**Re: Remedial Investigation/Focused Feasibility Study Work Plan Addendum
Standard Chlorine Chemical Co., Inc. Site
Kearny, Hudson County, New Jersey**

PROPOSED DELINEATION
BORING LOCATIONS

PROJECT NO: 3013-14
FIGURE 5-1

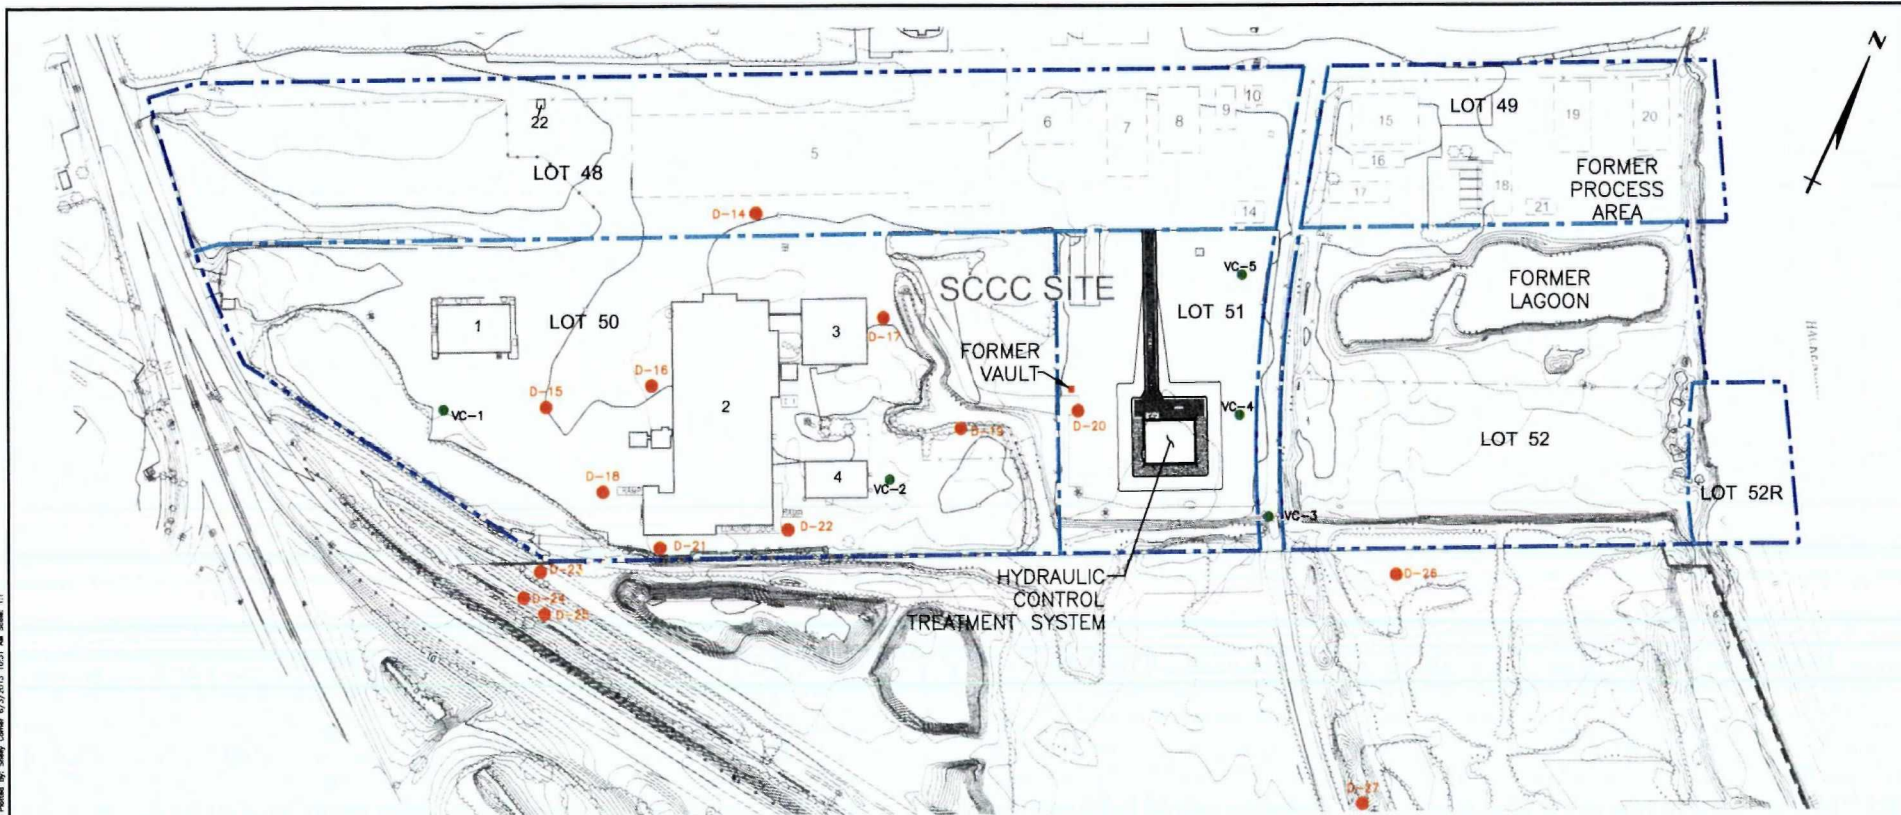
The Work Plan modifications involve the addition of three soil borings and the relocation of some boring locations. The proposed boring locations are shown on the revised Work Plan Figure 5-1, included in Attachment A. The rationale for the three additional borings is as follows:

- Proposed Boring D-20 – To investigate the area between the closed vault on Lot 51 and dense non-aqueous phase liquid (DNAPL) recovery well DRWL-9 where significant quantities of DNAPL have been recovered;
- Proposed Boring D-26 – To investigate the area on the Seaboard Site between the former lagoons and DRWL-11 where the greatest volume of DNAPL has been recovered.
- Proposed Boring D-27 – To investigate the possible presence of DNAPL in the area south of recovery DRWL-11 on the Seaboard Site where existing geologic information suggests that a low spot in the upper surface of the varved clay confining unit may exist.

Some of the borings have been relocated to investigate the following areas:

- Proposed Boring D-14 - The septic tank south of Building 5 on Lot 48;

- Proposed Borings D-15 and D-16 – The former tank farm area west of Building No. 2;
- Proposed Boring D-19 – The former drainage ditch in the center of the Site;
- Proposed Boring VC-2 – The septic tank to the east of Building 4;
- Proposed Borings VC-4 and VC-5 – The area just west of the lagoon area and former process area, respectively.
